Re: COMMENTS ON PROPOSED AMENDMENTS TO THE BASIN PLAN TO
INCORPORATE A PROGRAM OF IMPLEMENTATION CONSISTING OF
STAKEHOLDER-DEVELOPED GROUNDWATER QUALITY MANAGEMENT
MEASURES FOR SALT AND NUTRIENTS IN THE UPPER SANTA CLARA
RIVER BASIN

Salt and Nutrient Management Plan Measures for the Upper Santa Clara River Basin

Chloride in SCVSD Discharges

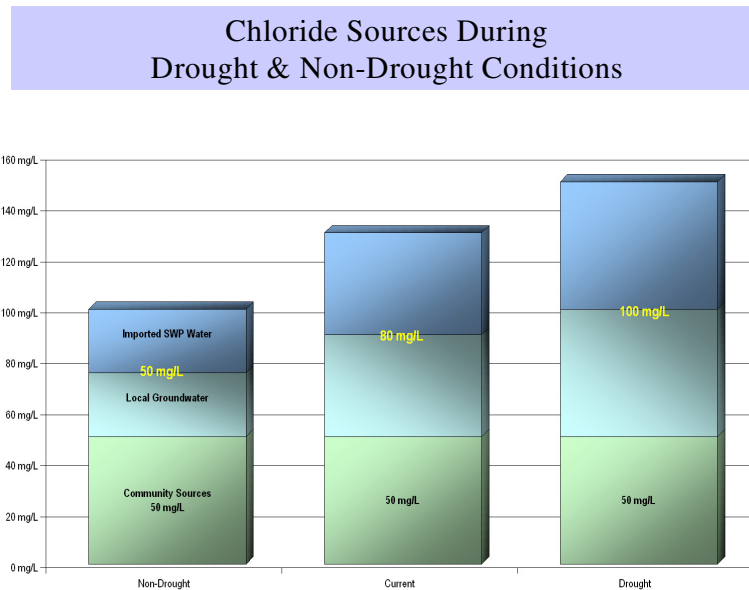
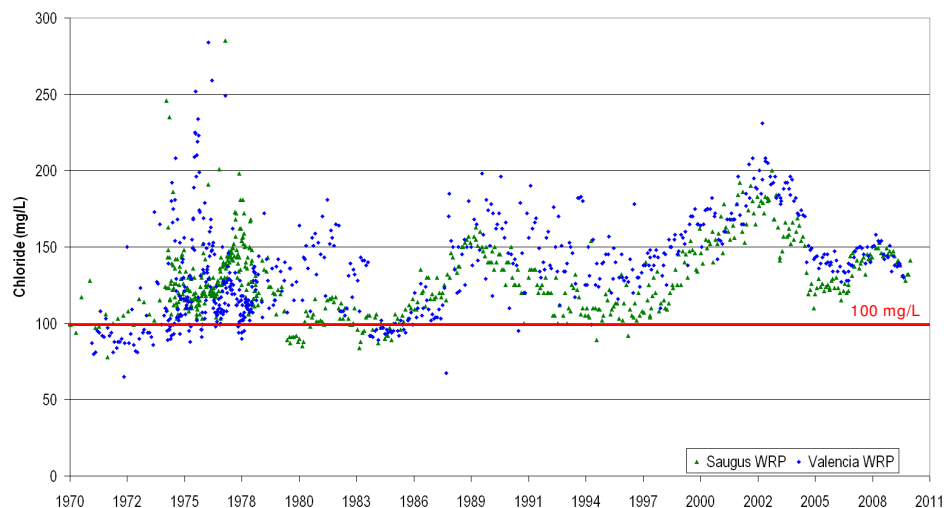
This is an inaccurate statement since state water is often higher in chlorides than local ground water. State water is especially high in chlorides during periods of drought that affect the San Joaquin Delta. The two charts below from a presentation made by the Los Angeles County Sanitation Districts, illustrate the loading of chlorides in state water.
